addendum no. 1

STATE OF WASHINGTON DEPARTMENT OF MILITARY –
STATE PROJECT NUMBER 2024-610
CAMP MURRAY BUILDING 1 (JFHQ) GENERATOR REPLACEMENT

September 10, 2025

Washington Military Department – Building 1 (JFHQ)
Generator Replacement – Addendum 1

G0.1

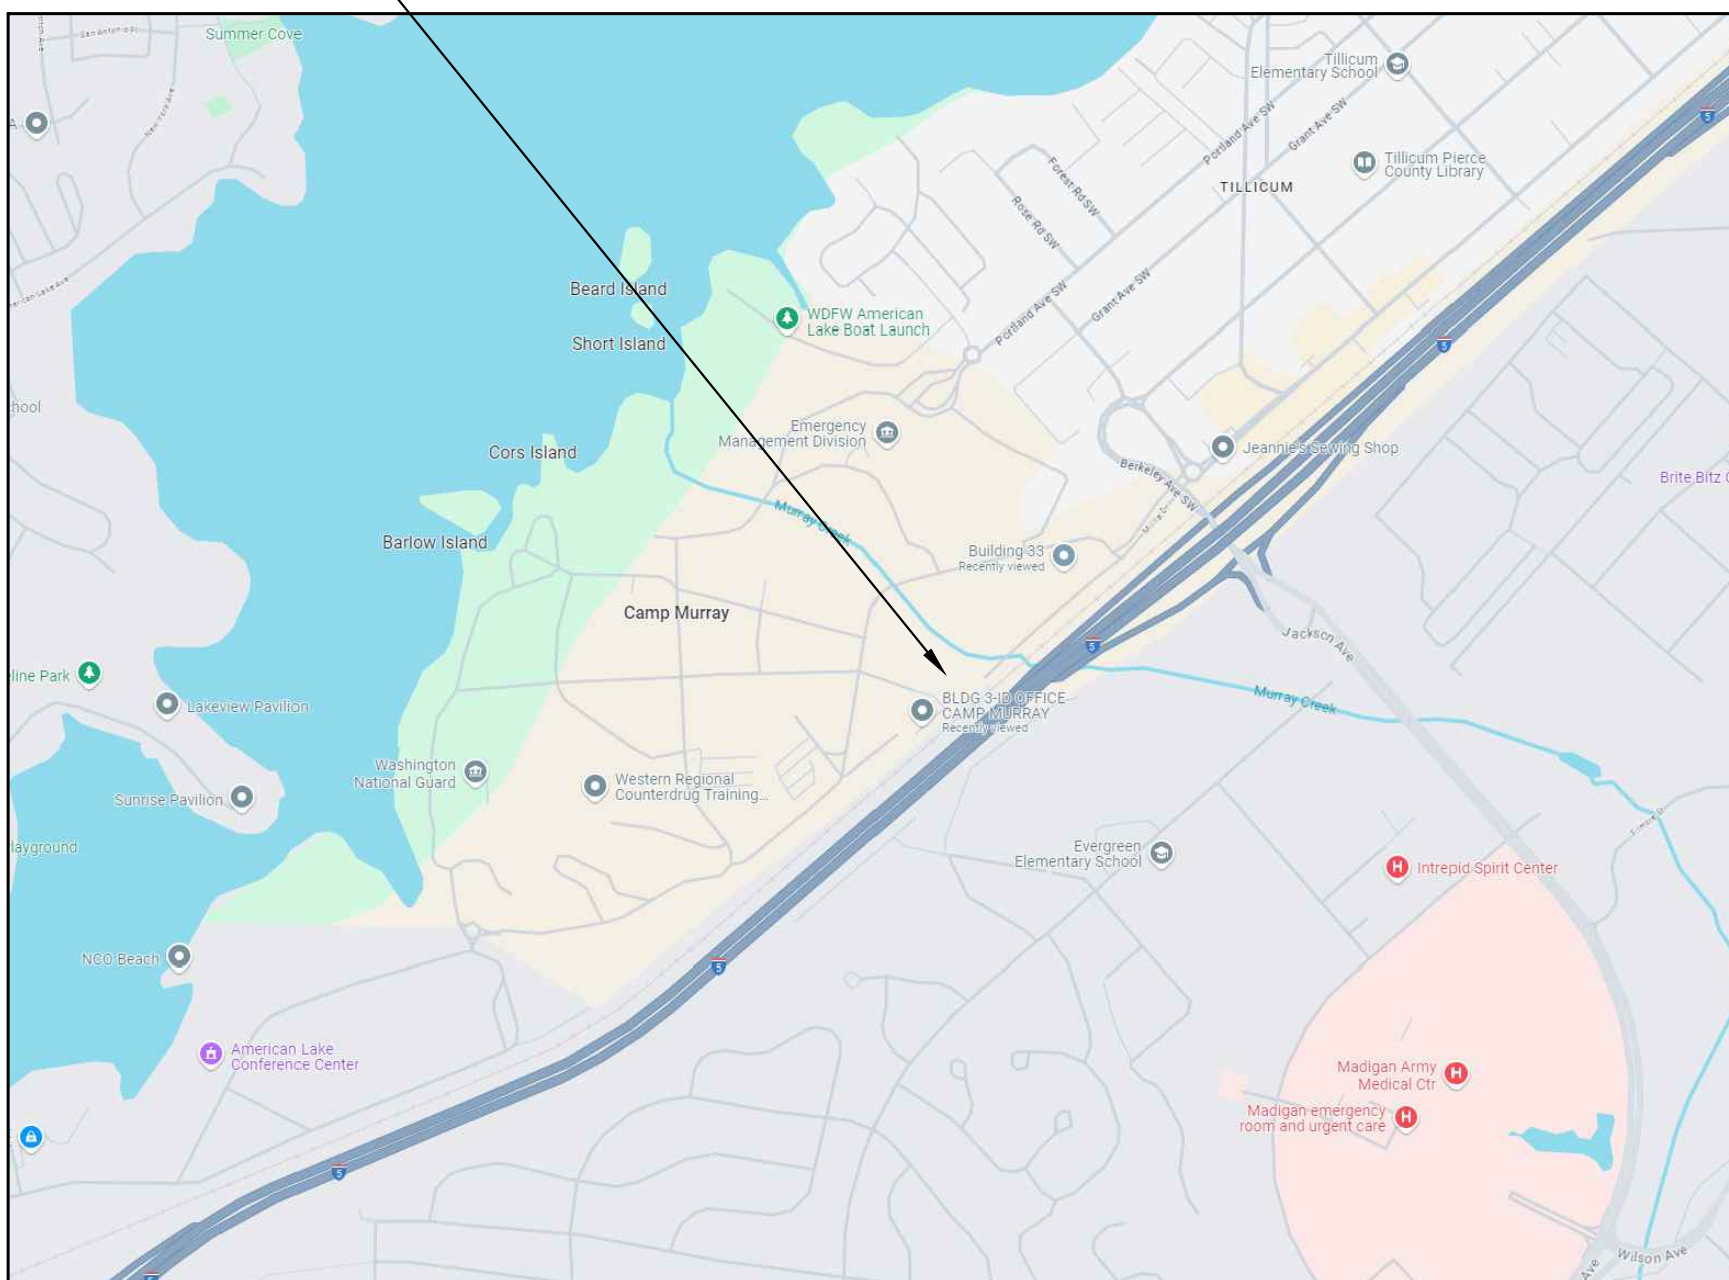
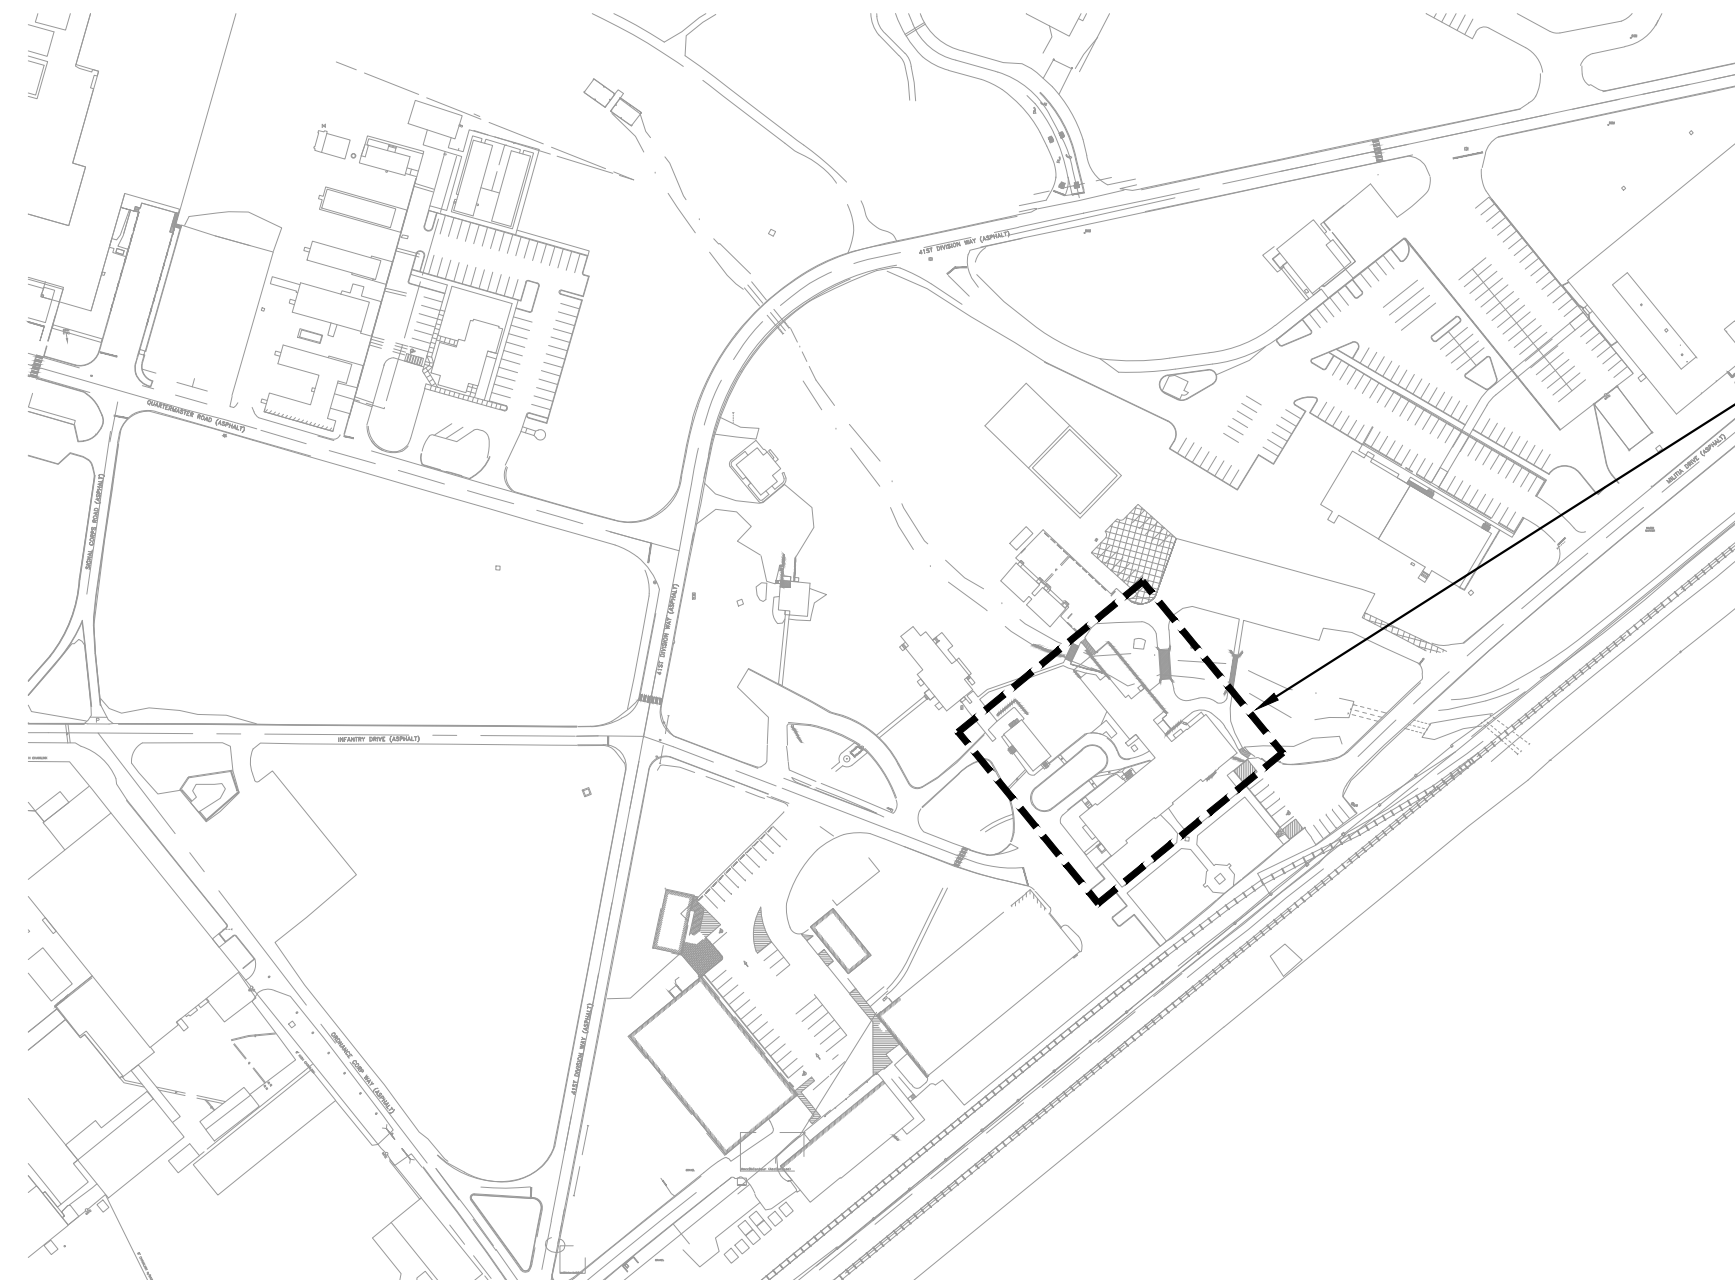
1.15 DRAWING SHEET G0.1 – COVER SHEET

REVISE: summary of work paragraph as shown on revised sheet G0.1.

ADD: Deferred Structural Submittal information as shown on revised sheet G0.1.

REPLACEMENT OF EXISTING GENERATOR AT BUILDING 1 WITH NEW GENERATOR AND ALL ASSOCIATED ELECTRICAL AND GENERAL CONSTRUCTION WORK. SCOPE INCLUDES A NEW DIESEL GENERATOR IN PLACE OF THE EXISTING DIESEL GENERATOR, BOLLARD INSTALLATION, AND CONCRETE PAD REWORK

ADDITIVE ALTERNATE NO. 1 - REPLACE EXISTING GENERATOR CONCRETE PAD WITH NEW.

PROVIDE DEFERRED STRUCTURAL SUBMITTAL STAMPED BY CONTRACTOR'S STRUCTURAL ENGINEER. INCLUDE CODE-REQUIRED STRUCTURAL PERMITTING REQUIREMENTS, INCLUDING, BUT NO LIMITED TO:

- REPLACE EXISTING CONCRETE PAD WITH NEW CONCRETE PAD TO SUPPORT NEW GENERATOR.
- CONNECTIONS OF THE NEW GENERATOR TO THE NEW CONCRETE PAD FOR THE GENERATOR.
- PROVIDE STRUCTURAL CALCULATION FOR THE ABOVE ITEMS 1 & 2 PERFORMED FOR A SEISMIC IMPORTANCE FACTOR OF 1.5.
- PROVIDE SEISMIC SUPPORT DETAILING FOR NEW ABOVE GRADE CONDUIT AND PIPE AS REQUIRED.

G0.2

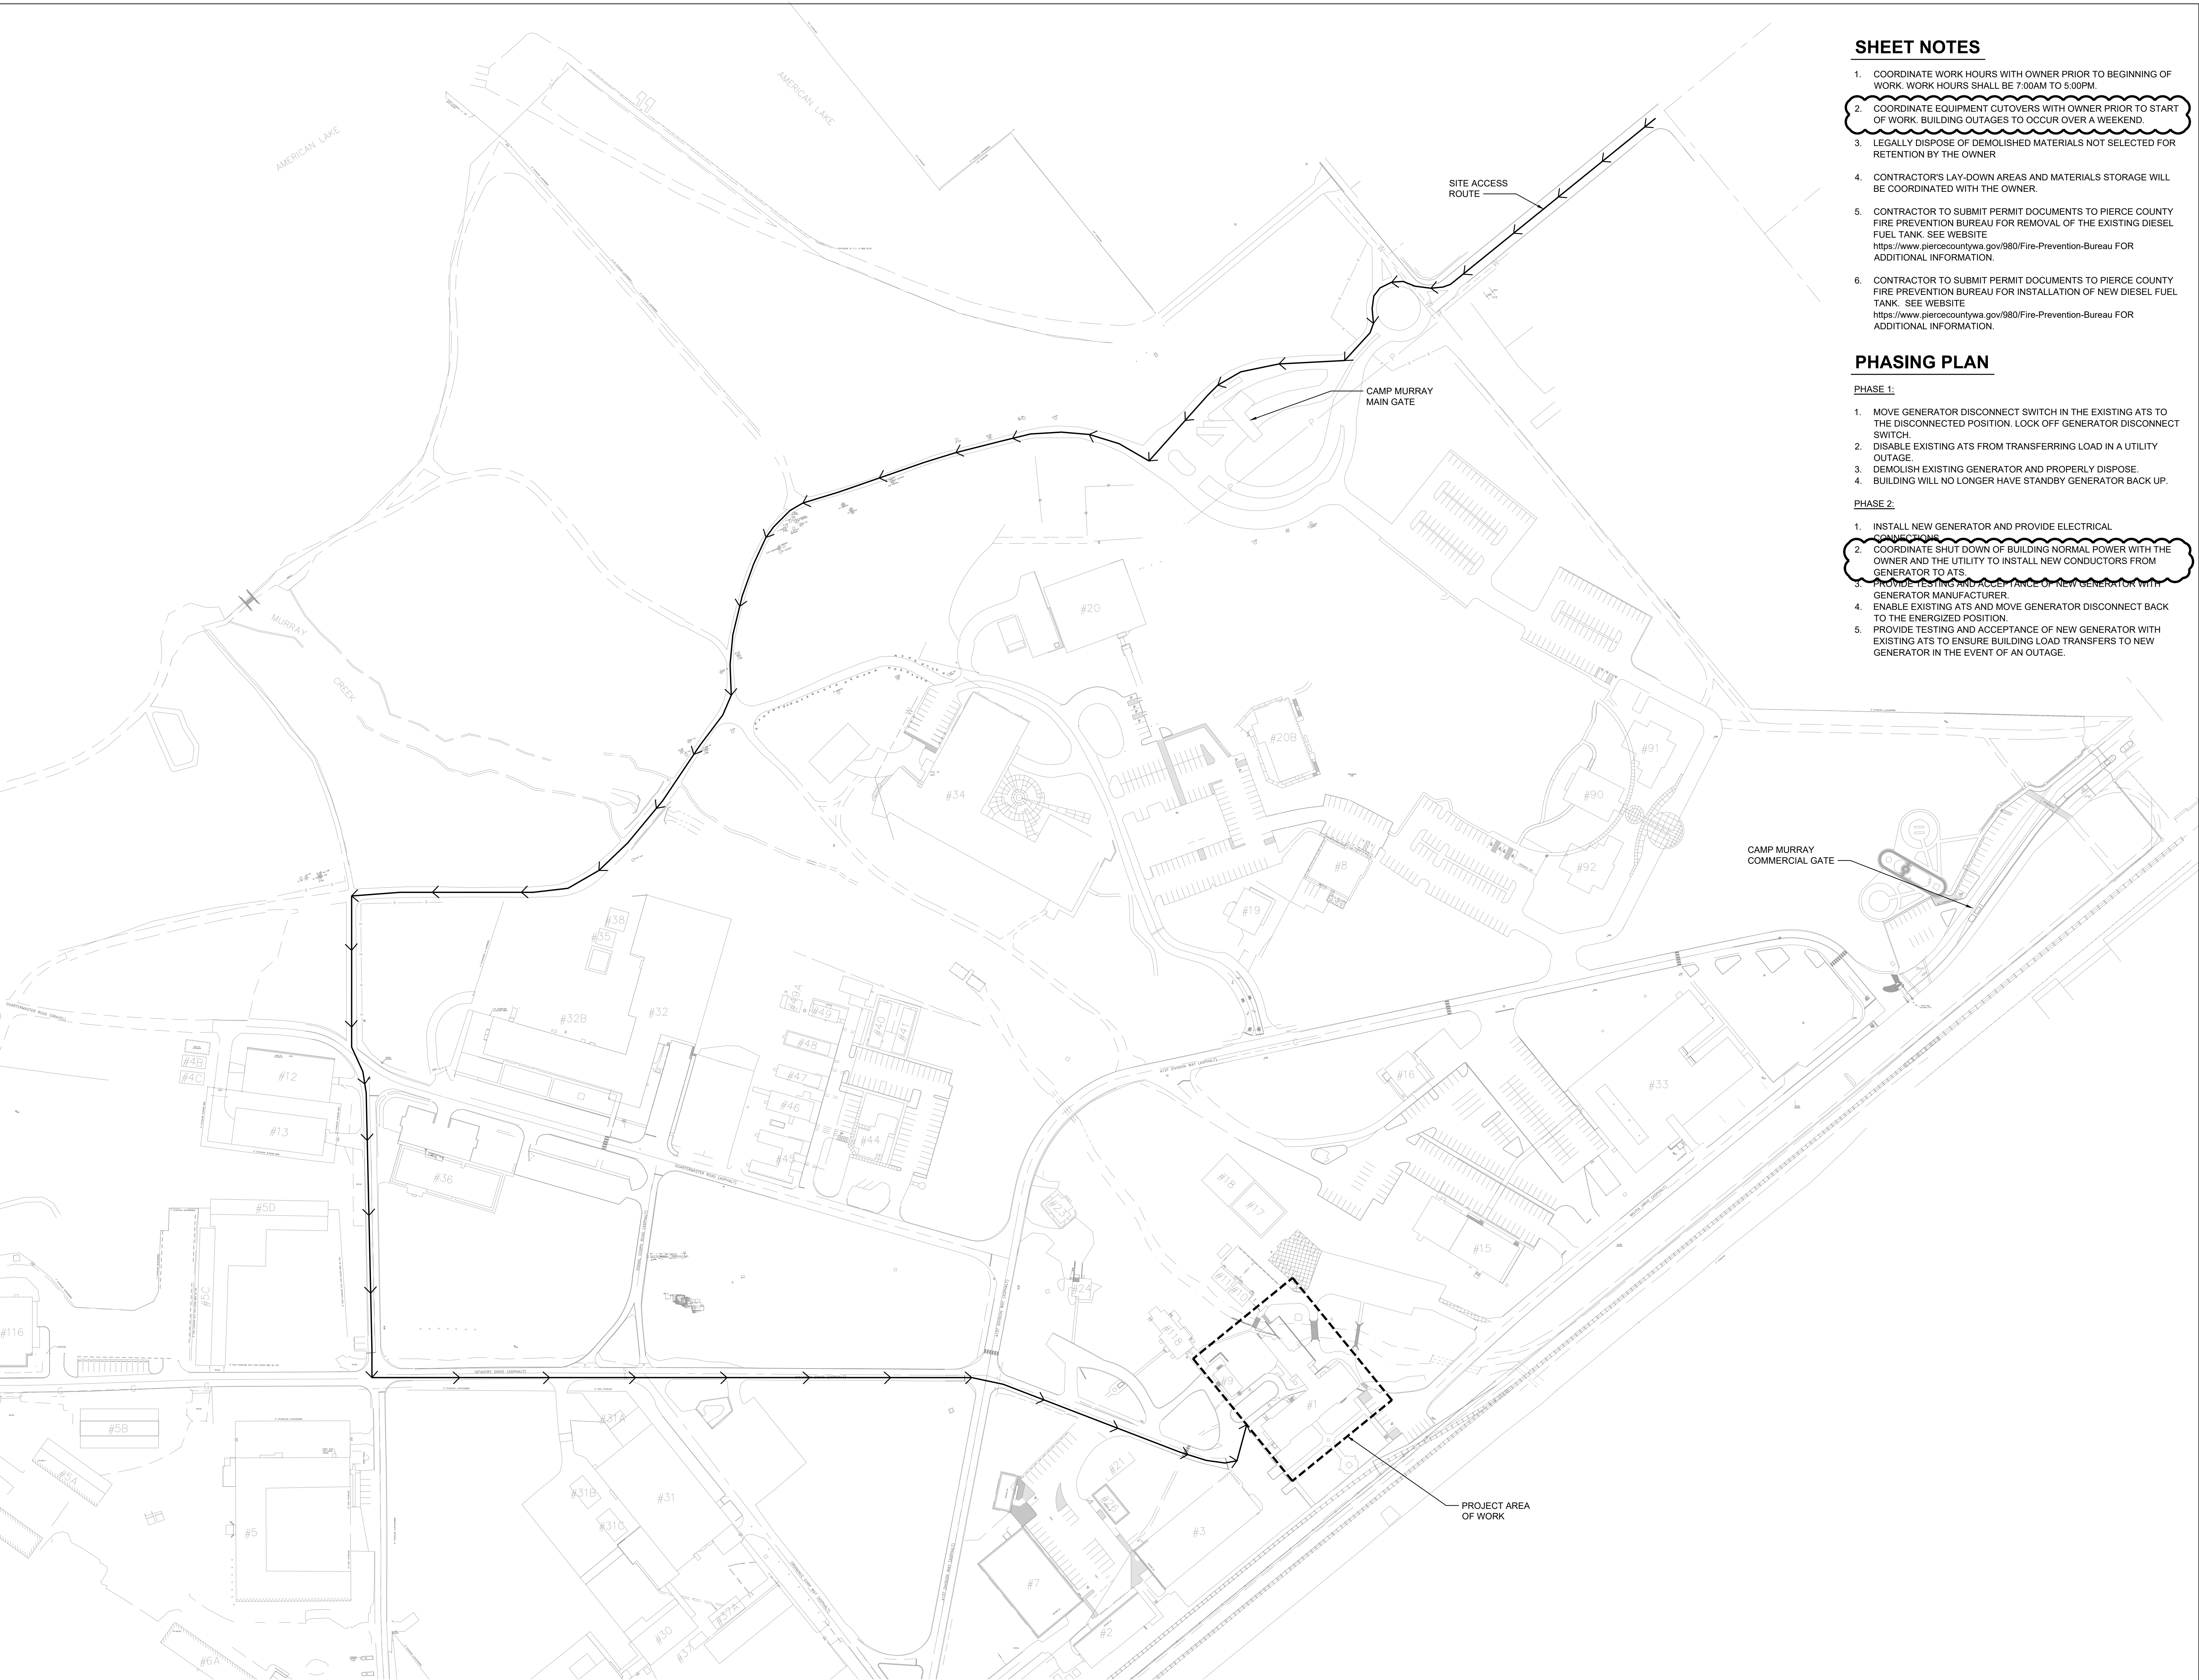
1.16 DRAWING SHEET G0.2 – PHASING AND SITE PLAN

REVISE: sheet notes and phasing plan as shown on revised sheet G0.2.

1. MOVE GENERATOR DISCONNECT SWITCH IN THE EXISTING ATS TO THE DISCONNECTED POSITION. LOCK OFF GENERATOR DISCONNECT SWITCH.
2. DISABLE EXISTING ATS FROM TRANSFERRING LOAD IN A UTILITY OUTAGE.
3. DEMOLISH EXISTING GENERATOR AND PROPERLY DISPOSE.
4. BUILDING WILL NO LONGER HAVE STANDBY GENERATOR BACK UP.

1. INSTALL NEW GENERATOR AND PROVIDE ELECTRICAL CONNECTIONS.
2. IMMEDIATELY SHUT DOWN OF BUILDING NORMAL POWER WITH THE GENERATOR AND THE UTILITY TO INSTALL NEW CONDUCTORS FROM GENERATOR TO ATS.
3. PROVIDE TESTING AND ACCEPTANCE OF NEW GENERATOR WITH GENERATOR MANUFACTURER.
4. ENABLE EXISTING ATS AND MOVE GENERATOR DISCONNECT BACK TO THE ENERGIZED POSITION.
5. PROVIDE TESTING AND ACCEPTANCE OF NEW GENERATOR WITH EXISTING ATS TO ENSURE BUILDING LOAD TRANSFERS TO NEW GENERATOR IN THE EVENT OF AN OUTAGE.

E9.1

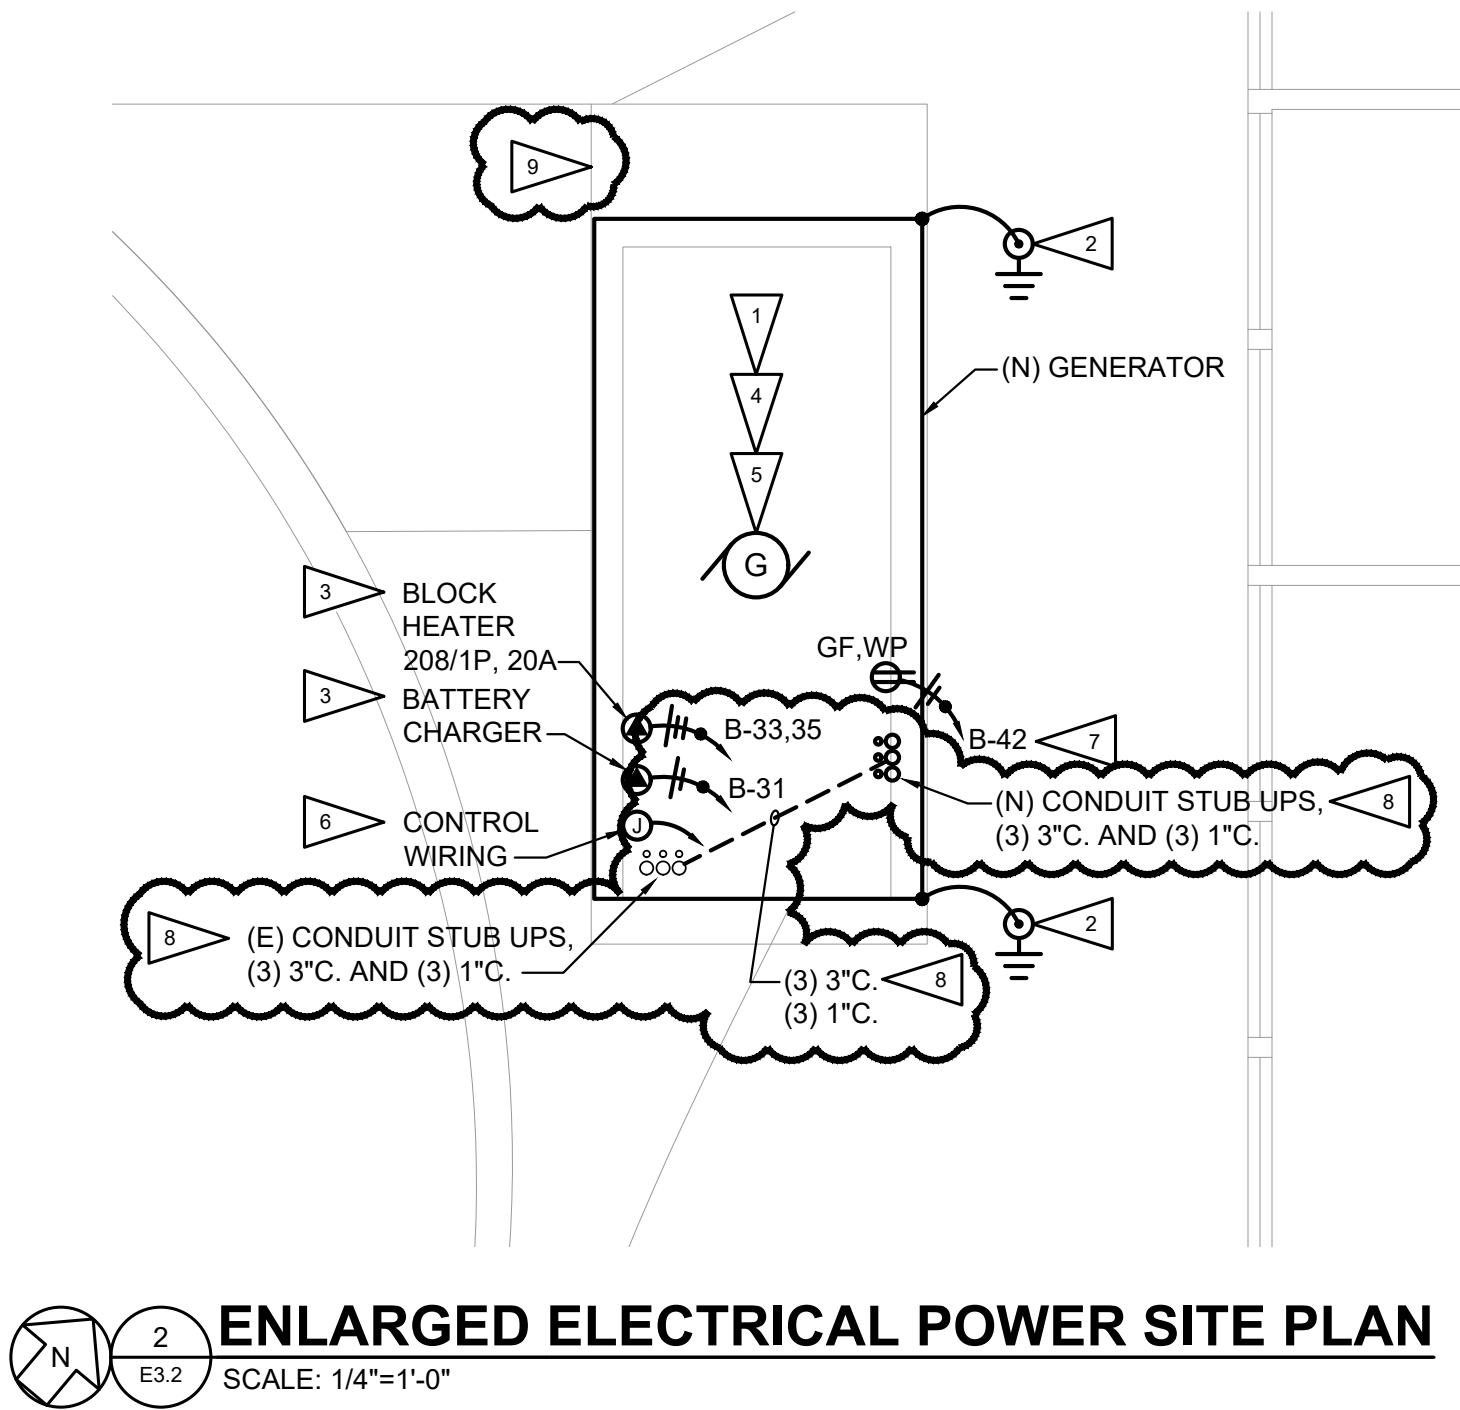
1.08 Is cable splicing allowed?

1.19 DRAWING SHEET E9.1 – ELECTRICAL PARTIAL ONE-LINE DIAGRAMS

ADD: Scope to demolish existing conductors from the existing generator to the existing ATS as shown on revised sheet E9.1.

ADD: Scope to provide new conductors from the new generator to the existing ATS, and provide scope to extend new conduit as shown on revised sheet E9.1.

REVISE: Flag notes as shown on revised sheet E9.1.

Response: No, splices are not indicated in the drawing set. The contractor will be required to replace the existing conductors to the generator with new. See updated sheet E3.2 and E9.1
